Historic Preservation Commission

October 10, 2019

Certificate of Appropriateness

1616 Grande Avenue SE

Proposed New Garage

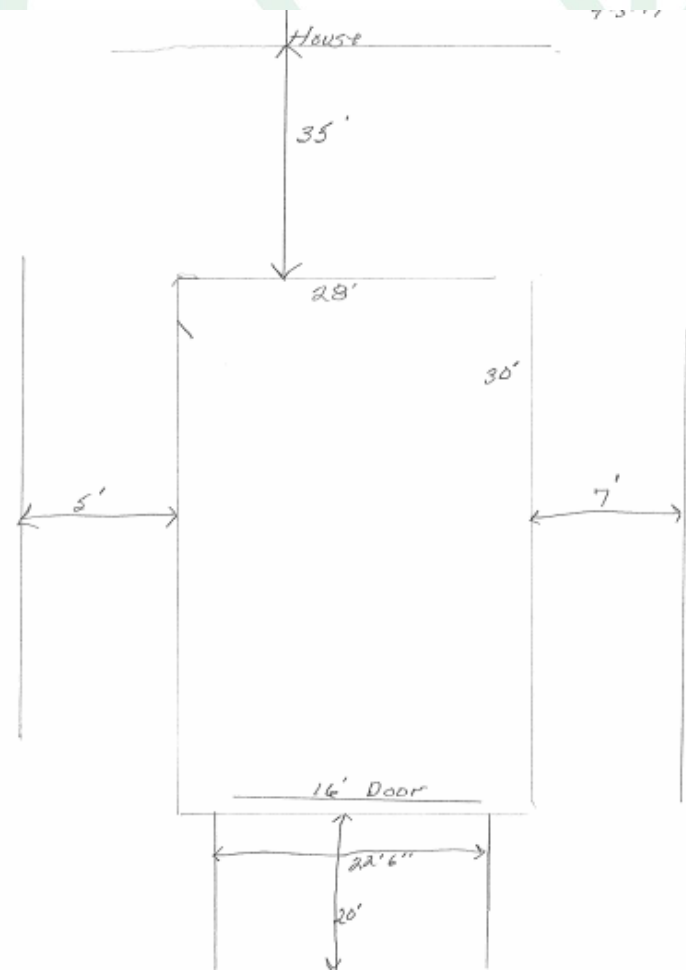
Staff recommends denial of the use of vinyl, but would recommend allowing applicant to use wood-like alternative material for the siding.
